From: Tony Lawrence
Sent: Wednesday, January 08, 2014 3:24 PM
To: All Dirs All Rgns - PT; All Dirs All Rgns - SR
Subject: MAZDA DEALER NOTICE - SERVICE BULLETIN RELEASE

SERVICE BULLETIN RELEASE - 01/08/2014

Subject: RATTLE NOISE FROM REAR BRAKE CALIPER	Bulletin No: 04-001/14
	Last Issued: 1/8/2014

2014 Mazda6 vehicles with VINs lower than JM1 GJ ***** 149693 (produced before October 03, 2013)

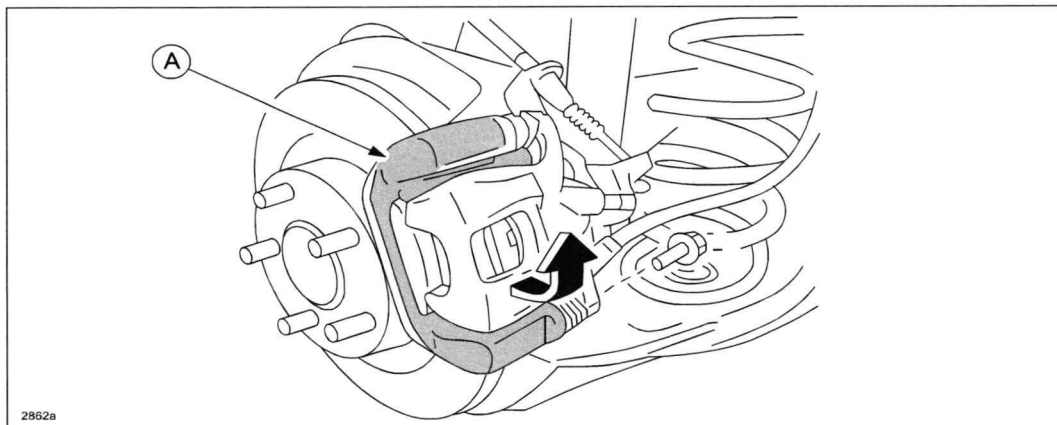
A rattle noise may be heard from the rear part of the vehicle when driving on rough roads. If the driver puts his/her foot on the brake pedal, the noise disappears. The rear brake pad(s) may be moving inside the caliper(s), causing a rattling noise.

1. Verify customer concern.
2. When noise is present, lightly depress the brake pedal. Does the noise disappear?
 - a. Yes - Proceed to Step 3.
 - b. No - This bulletin does not apply. Proceed to step 4.
3. Replace the rear brake caliper mounting support (A) and brake pad shim and retainer at the affected side. Refer to MS3 online or Workshop Manual (section 04-11 REAR BRAKE (DISC) REMOVAL/INSTALLATION). Then proceed to step 5.

Part Number	Description	Qty.	Notes
GHT2-26-281A	Brake Caliper Mounting Support	1	One side
GHY9-26-49ZB	Brake Attachment Kit (Rear)	1	Both sides
